# UNITED STATES PATENT AND TRADEMARK OFFICE

APPLICATION NO.	FILING DATE	FIRST NAMED INVENTOR	ATTORNEY DOCKET NO.	CONFIRMATION NO.
09/970,015	10/03/2001	Paul Vegliante	2112-342.1 US	2684

**Office Action Summary**

Diagram 1. Figure 3 in Lucas.

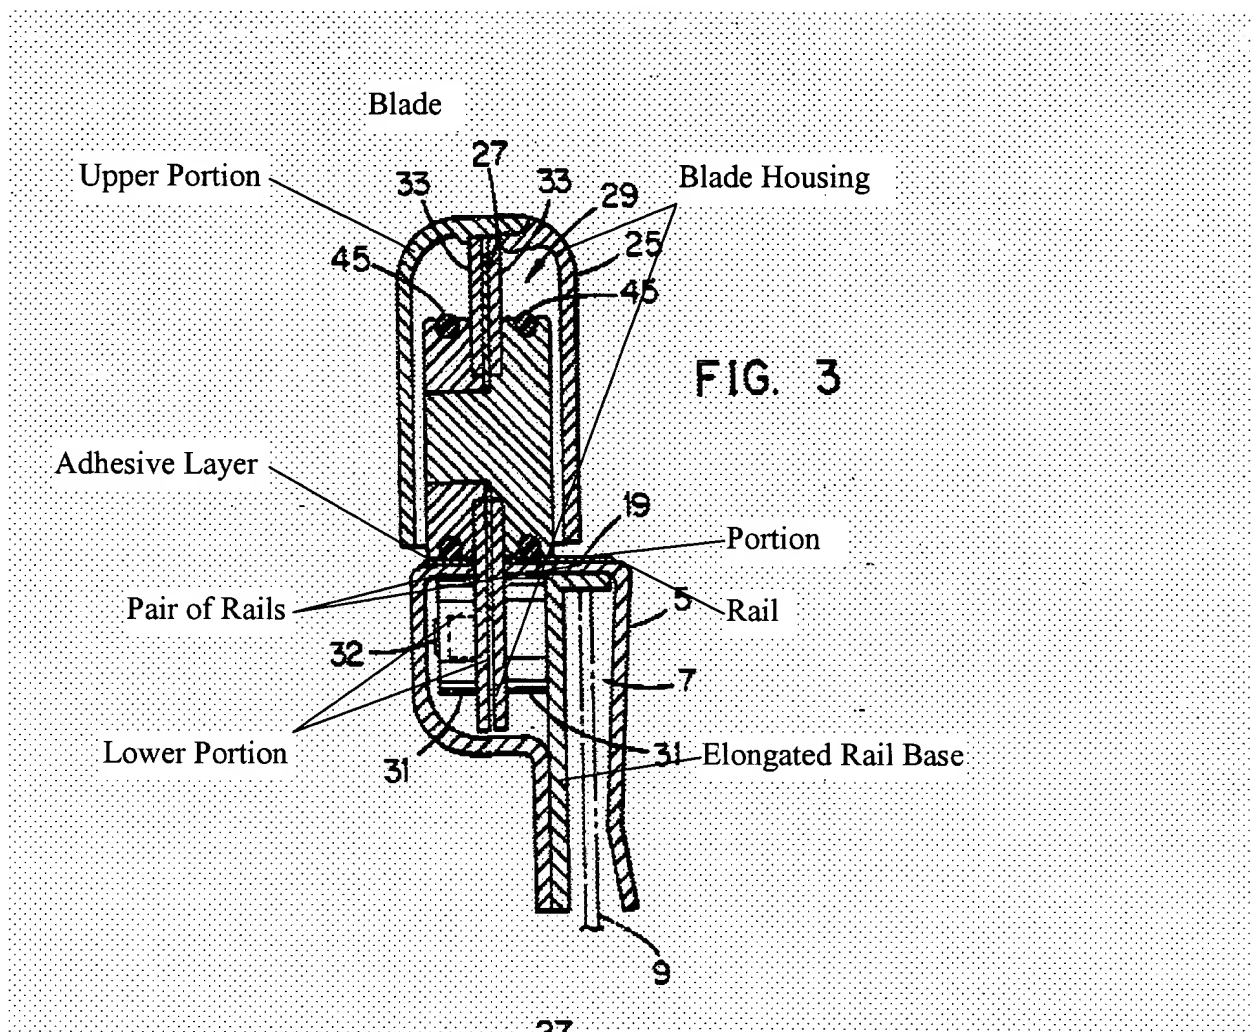
3. Claims 1, 3-7, 11-17, 20-23, 35-40 and 42-44 are rejected under 35 U.S.C. 103(a) as being unpatentable over Lucas. Lucas discloses everything as noted in Diagram 1, and discloses clinging properties in column 3, line 8; channel 13; bottom edge of upper portion of blade housing protrudes on either side of blade in figure 3; end surface of upper portion is rounded and inclined upward as shown in figure 2; tracking device 34; tubular base 31; channel has tubular shape as shown in figure 3; Lucas does not disclose materials having hardness in the shore A range; that are non-porous; that are smooth; made of rigid PVC, acetal, silicon, plastic, rubber, acrylic, polyvinyl chloride comprising at least 10% plasticizer, silicon elastimer, and combinations thereof; and being flexible. It would have been obvious to one of ordinary skill in the art to provide the elements mentioned above for the purpose of making the apparatus in Lucas more durable for re-use. It has been held to be within the general skill of a worker in the art to select a known material on the basis of its suitability for the intended use as a matter of obvious design choice. Note in claims 7, 38 and 39 that coextrusion is a process that is well known in the manufacturing of the materials mentioned above. In further support of Examiner's position that

4. Claims 18 and 19 are rejected under 35 U.S.C. 103(a) as being unpatentable over Lucas as applied to claim 1, and further in view of Keene et al (3,277,760), hereafter Keene. Lucas discloses channel 13; pair of rails, upper section and lower section shown in Diagram 1 below. Lucas does not disclose a protrusion and does not disclose a blade housing that snap fits into a protrusion. However, Keene teaches protrusion 18, 29, 40, and discloses blade housing 40 that snap fits into the protrusion. It would have been obvious to provide a blade housing that snap fits into a protrusion in Lucas as taught by Keene in order to prevent the blade housing from sliding out of the elongated rail base.

Applicant asserts that Lucas, Jr. et al. does not disclose a bottom edge of an upper portion of a blade housing protrudes on either end from the blade and an end surface of the upper portion of the blade housing being rounded and inclined upwardly and from either end of the bottom edge. It is believed that figure 2 shows upper portion 25 has a bottom edge protruding on either end of blade 27 at the bottom edge, and that the end surface of upper portion 25 is rounded and inclined upward at either end of the bottom edge due to the rounded corners of the upper portion 25.
